Land Use Petition: SLUP-17-001

Date of Staff Recommendation Preparation: April 17, 2017

SITE PLAN REVIEW

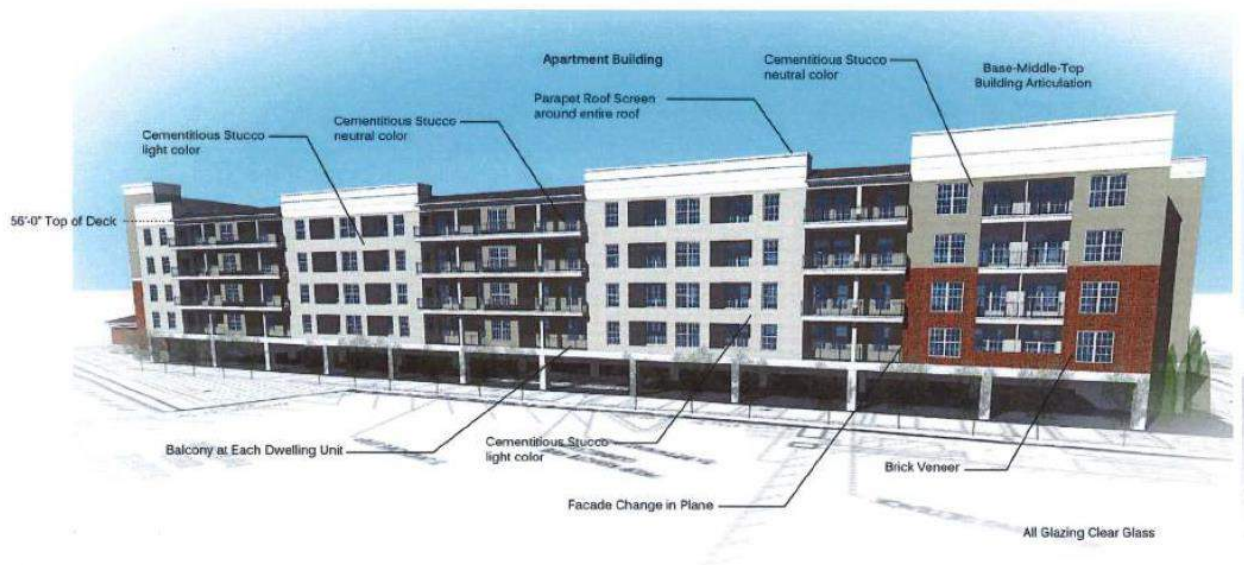
Building size and location: A 91,325 square foot building is proposed. The circular building front is located a maximum of 20 feet from the Northlake Parkway right of way. The rear building setback is 20 feet.

Access and parking: The site plan indicates a curb cut onto Northlake Parkway. Additional right of way along Northlake Parkway is proposed to be dedicated. Inter-parcel access is provided to the properties to the south. No access from the subject development site will be permitted directly onto Rockwood Road (the site plan was revised to incorporate this recommendation), although residents of the development could still use Rockwood Road via the inter-parcel access. Parking is proposed mostly underneath the building. The site plan indicates that 114 parking spaces are provided (112 required). There are five handicapped parking spaces which meets requirements. The trash receptacle is located at the rear of the site with adequate loading space. The trash receptacle is proposed to be enclosed as required.

Landscaping: The site plan incorporates 5' wide landscape strips along the rear and side property lines, as well as landscaping in the front of the building.

Streetscape: A 10' wide sidewalk and 5' wide furniture zone are shown on the site plan, along with a proposed bike rack.
